IRF21/4899

Gateway determination report – PP- 2021-6620

Bathurst Regional LEP 2014 –inserting a new site specific clause to increase the maximum FSR and the maximum building height at 250 Howick Street and George Street, Bathurst to facilitate a new health services facility and a multi storey car park.

Figure 2 Amendments to the FSR Map (source: base map, LEP, FSR_011B)

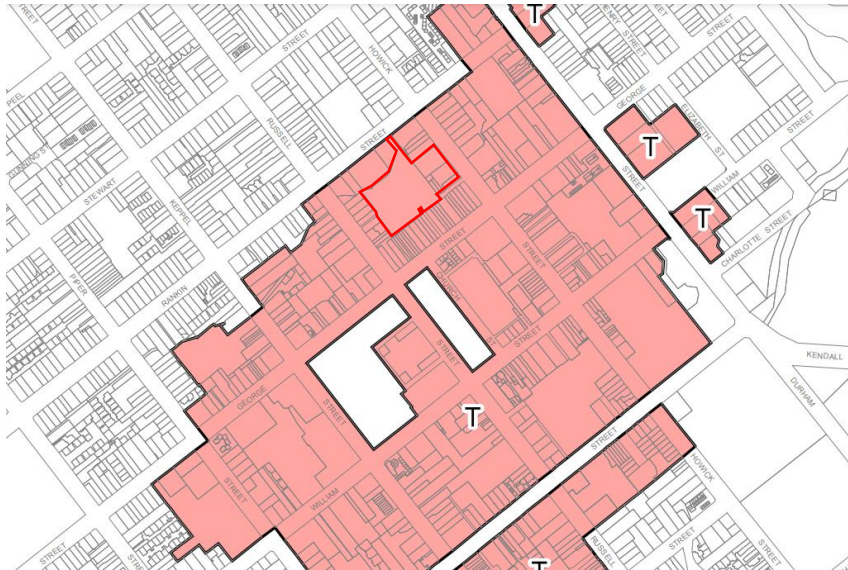
The Department notes Council's preference to outline the proposed amendments in words. Notwithstanding, the Department considers that it may be necessary to identify the extent of the land (i.e. area of the site) subject to the new clause is mapped and identified on a map. The Department recommends that Council outline the extent of the site on the respective FSR and Building Height Maps (refer to **Figures 2 and 3**). References to the new clause is to be added to the legends of these maps. The final mechanism to achieve the intended outcome will be determined in consultation with Parliamentary Counsel.

Figure 8 Deriving the maximum building height for the site using the BTCMP methodology

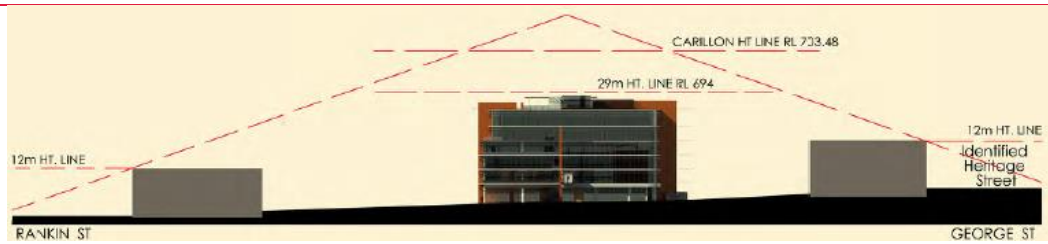
Environmental Impact	Assessment
Bulk and Scale	<p>The site is identified as having potential for increased height and density under Council's draft BTCMP. The draft BTCMP sets out a methodology to determine suitable increase in density and height controls for eligible sites. The new building height is to be derived by drawing a view line from the eye level height of an average adult (1.6m) standing on any point of a heritage street (George Street, William Street and the southern portion of Howick Street and Keppel Street) to the current LEP height control. The maximum building height is however to be limited by at least a storey (approximately 3m) below the height datum of the State heritage listed Bathurst War Memorial Carillon building (RL 703.48). (Figure 8)</p>

The planning proposal loosely applied the above methodology to derive the building height (29m for the BIMC and 21m for the GSC). The planning proposal considers that the proposed height and density (FSR of 2.6:1 for the BIMC and no change to the FSR for the GSC) are acceptable as the proposed building height remains an entire storey (RL 694) below the height of the Carillion building (RL 703.48) and upper-level setbacks and modulation of the built form at Development Application stage will ensure that any future development proposal is of an appropriate bulk and scale.

The Department accepts that the subject site is centrally located on an underutilised lot and can benefit from some increased density and height as also identified by the draft BTCMP. The Department also notes that if the BTCMP height methodology were strictly applied from south east Howick Street, the development potential of the site would be limited to current planning controls, sterilising redevelopment of the site (**Figure 9**). The Department recognises that the BTCMP allows for some variation to the BTCMP height methodology for development blocks on certain street fronts like the northern end of Howard Street (location of the subject site) provided they respond to the predominant scale of Bathurst streets through significant upper level setbacks. The Department finds that:

- The planning proposal seeks a full building height increase to 29m for the BIMC site. Limited justification is offered on the impact of building envelope that is 29m in height and FSR of 2.6:1. The Department considers that the planning proposal should be assessing bulk and scale impacts for the proposed building envelope that is 29m in height and has an FSR of 2.6:1 from all four streetscapes and demonstrate how the envelope predominantly respond to the scale of Bathurst streets.

- c) clarify the bulk and scale impacts of a 29m and 21m high building envelope for the BIMC site and GSC site. Revised visual impact assessment is to be undertaken considering impacts of the full building envelope from all four streetscapes

Figure 10 Shadows cast by envelope at 9am during winter solstice

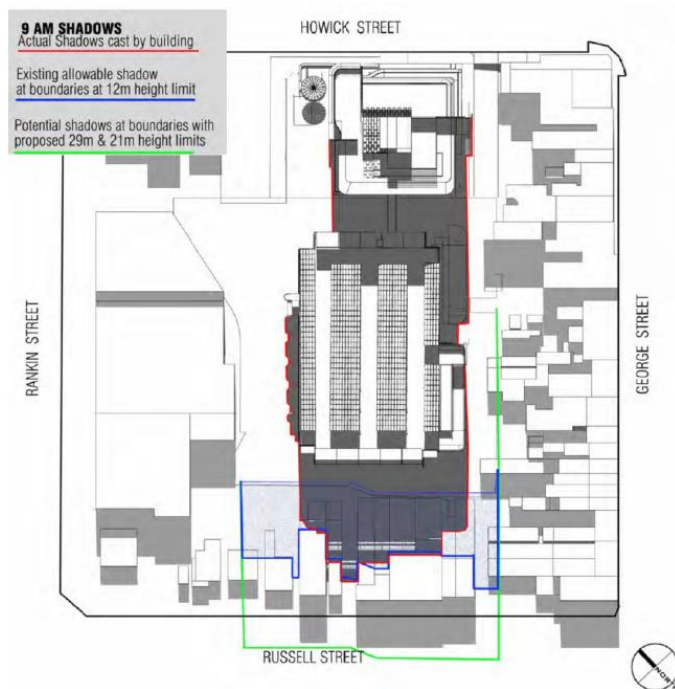
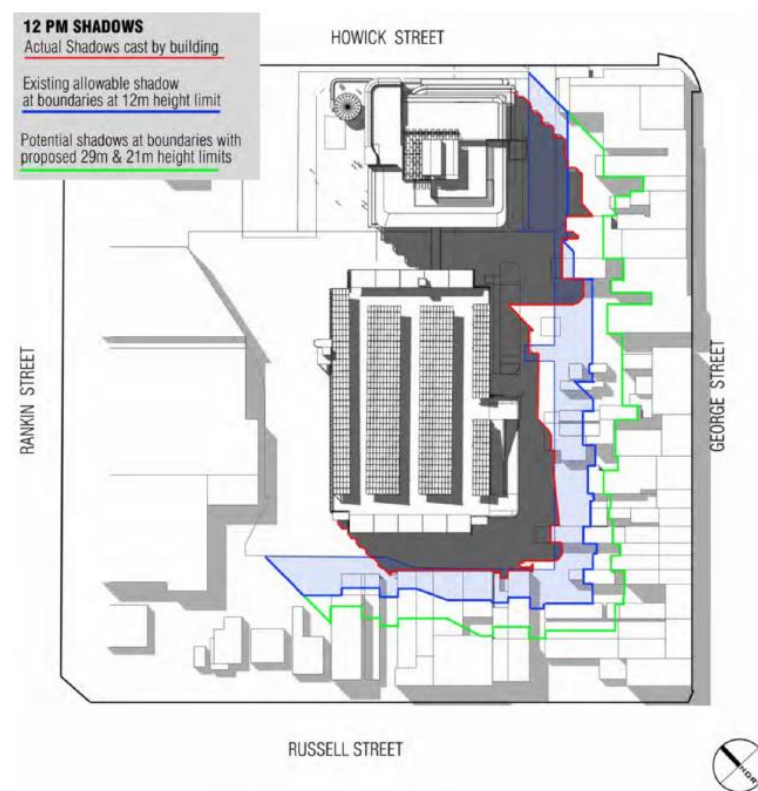
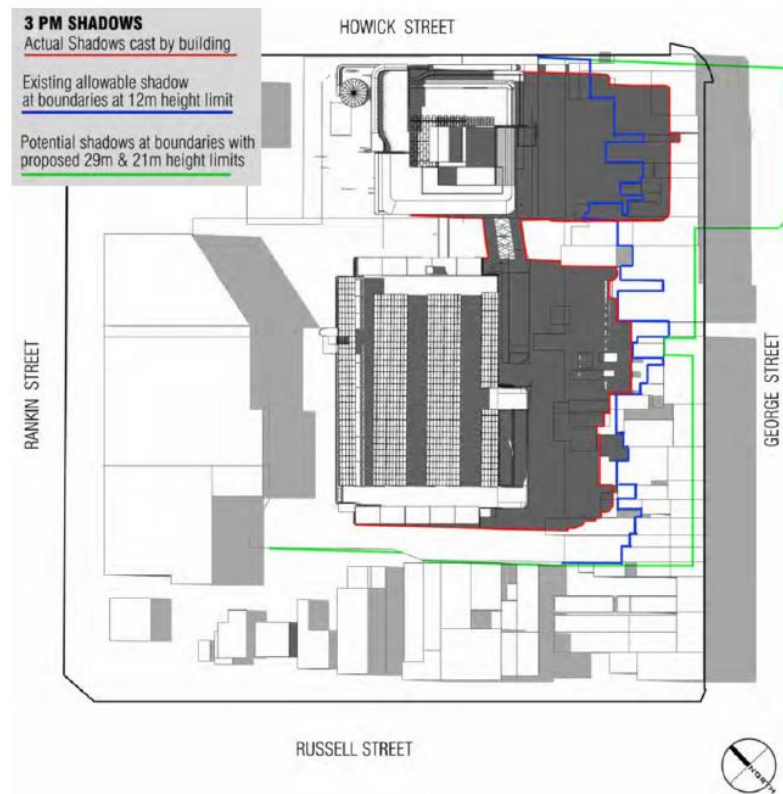
Overshadowing impact	<p>The planning proposal is accompanied by an Overshadowing Study (see Design Statement dated February 2022 (Appendix 2)). The study illustrates maximum shadows cast during winter solstice as a result of the proposed increase in building height and FSR. Based on the findings of the study, the planning proposal submits that the overall overshadowing impact is minimal. The proposal will not affect solar access to any residential properties. Most shadows fall on to the roofs of shops and commercial premises to the east (along Russell Street) and south (George Street) of the site (Figures 10 - 12).</p> <p>Based on the information provided:</p> <ul style="list-style-type: none"> The overall overshadowing impact is acceptable, noting that the overshadowing study submitted with the planning proposal illustrates the worst case scenario during winter solstice. The residential properties located to the north of the site along Howick Street remain unaffected by the proposal. A majority of the shadows resulting from the proposal fall on to roads or the roofs of commercial and retail shops along Russell Street and George Street. Overshadowing impact of any future BIMC and GSC proposal will be far less than the maximum impact of a 29m and 12m high building on the site (Figures 7 to 9) owing to some upper-level setbacks and modulation of the built form. In this instance, the shadows cast by the indicative scheme is comparable to shadows that would be cast by a proposal that complies with current building height controls. <p>The Department notes that any future development proposal for the site will also need to demonstrate how overshadowing is being minimised. Overshadowing impact is proposed to be one of the heads of consideration in the new design excellence clause that will apply to the site. As such, overshadowing impacts would be carefully considered at Development Application stage to ensure they are minimal.</p> <p>The Department however notes that the shadow diagrams submitted with the Design Statement differ from the shadow diagrams submitted with the Architectural Plans. A recommendation has been included as part of the Gateway Determination to resolve the discrepancy, verify the accuracy of the overshadowing study and clarify accurate overshadowing of a 29m and 21m building envelope for the purposes of this planning proposal application.</p>

- g) clarify if the overshadowing diagrams provided in the Design Statement dated February 2022 is accurate and resolve the discrepancy between the overshadowing diagrams provided in the Architectural Plans dated February 2022 and the Design Statement.
